## REQUEST FOR INFORMATION (RFI) RESPONSES

### PROJECT: IMPROVE MECHANICAL UTILITIES, PHASE 4

LOCATION: MALCOLM RANDALL VA MEDICAL CENTER, GAINESVILLE, FL

Project No.: 573-12-603

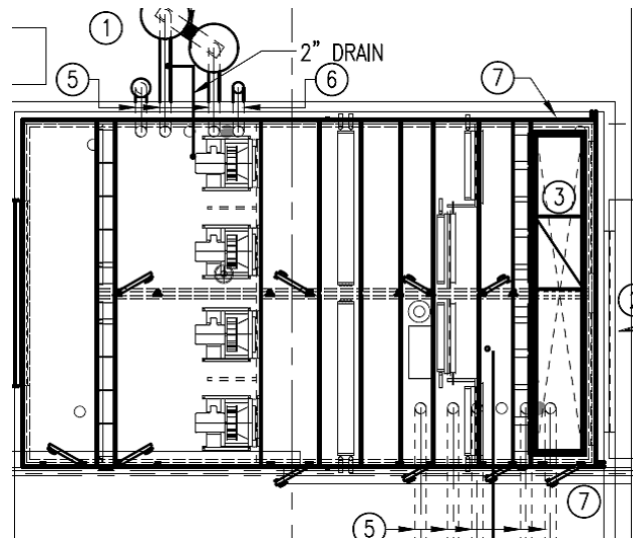
21	2) Is the contractor required to provide temporary air?	Yes, if it becomes necessary. In general the air handling unit replacements will not require temporary air, but if the contractor begins work in an area replacing terminals and does not complete the work prior to the next normal working day, he will have to provide temporary air to the affected rooms. In all circumstances setting temporary terminals with local thermostats should be all that is needed.
22	1. Section 2.1T of 237300 (Indoor Air Handling Units) specifies that "...distribution piping, strainers, isolation valves, control valves and automatic flow control valves...be pre-piped at the factory...ready for contractor's connection to chilled water supply and return...". The cooling coil detail on M503 also indicates such components being provided at the factory. However, the plan view on M101R shows full face cooling coils. With full face cooling coils as shown, there is not space internal to the ahu cabinet to provide the strainers, isolation valves, etc. Please clarify where and by whom (manufacturer or contractor) those components are to be installed.	This requirement for factory piping has been removed from the project. See revised section 23 73 00 and revised drawings and details.
